Title - Sujet Marine Facility WaterSystem Upgrade	
Solicitation No. - N° de l'invitation F1700-204309/A	Amendment No. - N° modif. 004
Client Reference No. - N° de référence du client F1700-204309	Date 2020-09-24
GETS Reference No. - N° de référence de SEAG PW-\$PWY-028-8811	
File No. - N° de dossier PWY-0-43048 (028)	CCC No./N° CCC - FMS No./N° VME
Solicitation Closes - L'invitation prend fin at - à 12:00 PM on - le 2020-10-13	Time Zone Fuseau horaire Pacific Daylight Saving Time PDT
F.O.B. - F.A.B. Plant-Usine: <input type="checkbox"/> Destination: <input checked="" type="checkbox"/> Other-Autre: <input type="checkbox"/>	
Address Enquiries to: - Adresser toutes questions à: Lam (PWY), Tian	Buyer Id - Id de l'acheteur pwy028
Telephone No. - N° de téléphone (604) 363-7968 ()	FAX No. - N° de FAX (604) 775-6633
Destination - of Goods, Services, and Construction: Destination - des biens, services et construction: DFO - Institute of Ocean Science – Sidney, BC

Amendment 004

Marine Facility Water System Upgrade
Institute of Ocean Sciences, Sidney, BC
Solicitation No: F1700-204309/A

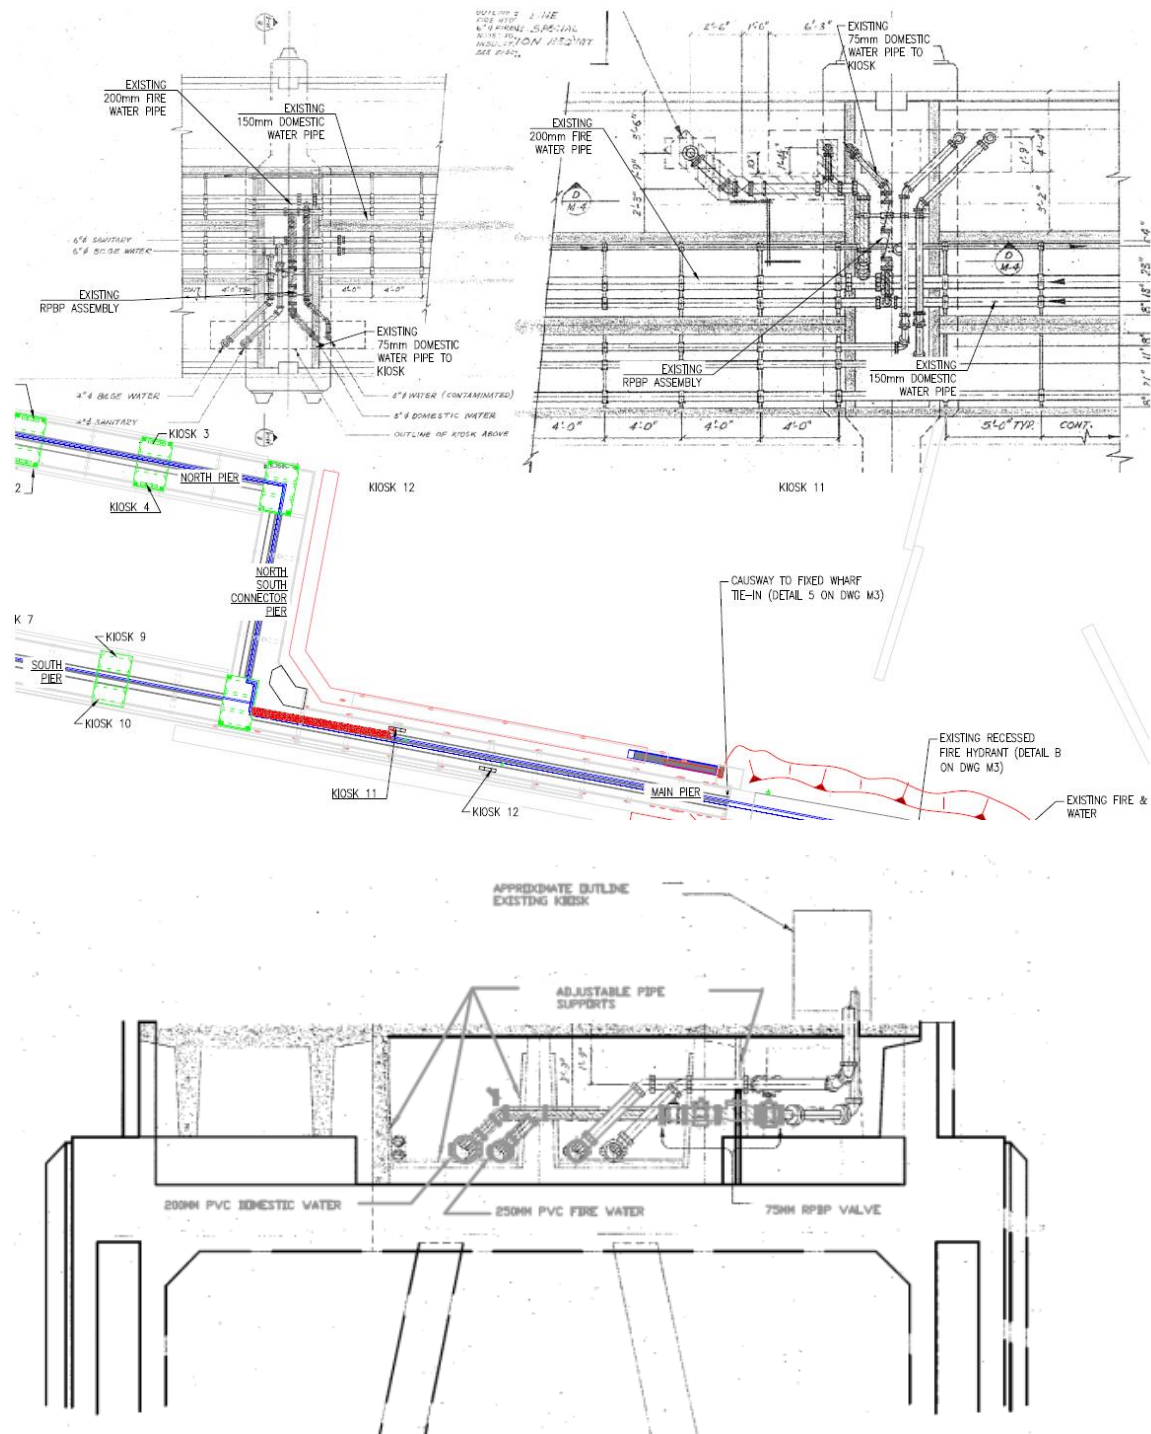
Question No 1: It appears the drawings were scanned in effecting the scale of the drawings. Can you please double check the scale and re issue the drawings?

Answer: Contractor shall follow the lengths noted on the drawings and not to scale. All major critical dimensions for takeoffs are noted on the drawings. If there is specific dimension requirements, please request accordingly.

Sketch 2: KIOSK 11 & 12 EXISTING PIPING AND RPBP ARRANGEMENT

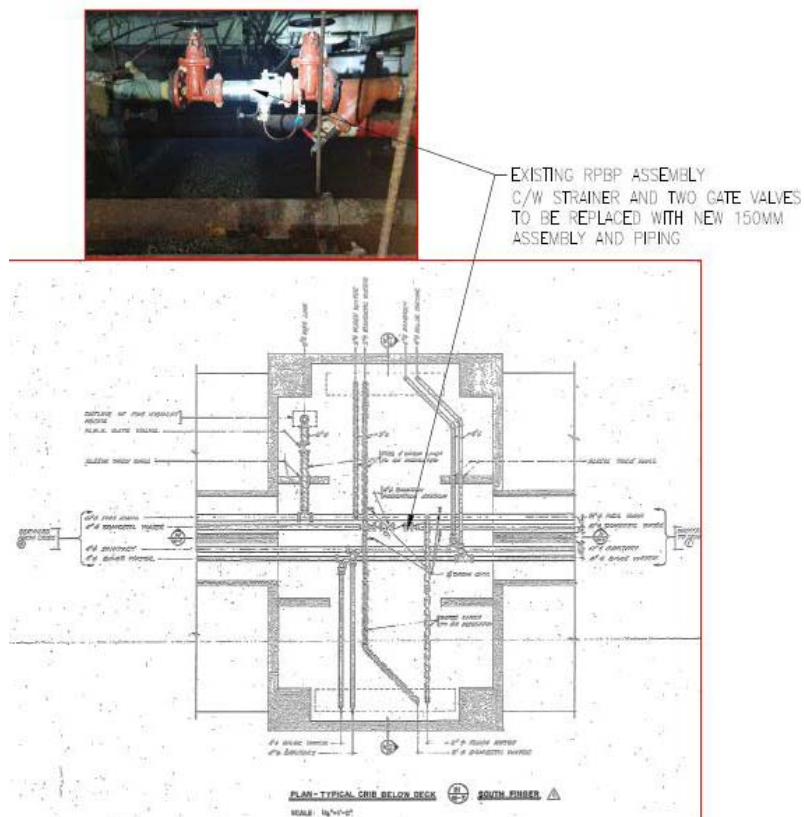
Question No 2: Item 10 on the tender form calls for RPBP valves. Can you please provide the sizes and locations of where these valves are to be installed?

Answer: One 150mm RPBP valve assembly (model Watts Series 4000SS, NRS, all flanged connections) is to be provided at each crib servicing two kiosks. At each Crib, there will be 150 to 200mm reducing tee from 200 mm domestic pipe. Followed by 150mm flanged wye strainer (Cla-val Model X43H 150# Flanges or Discover Valve SS316 Flanged TC-YSF) Downstream of the RPBP, a 150x75x75mm tee will service 75mm feed to each Kiosk. There are five RPBP units required at the Crib. Refer to Typical Sketch 1 for piping arrangement at each Crib.

For Kiosks 11 and 12, two additional 75mm RPBP valve assemblies C/W wye strainer (Cla-val Model X43H 150# Flanges or Discover Valve SS316 Flanged TC-YSF) shall be provided. Each RPBP assembly will be model Watts Series 4000SS, NRS, all flanged connections).

The general routing of the piping and RPBP assembly shall be similar to the existing arrangement as Depicted in Sketch 1 and 2.
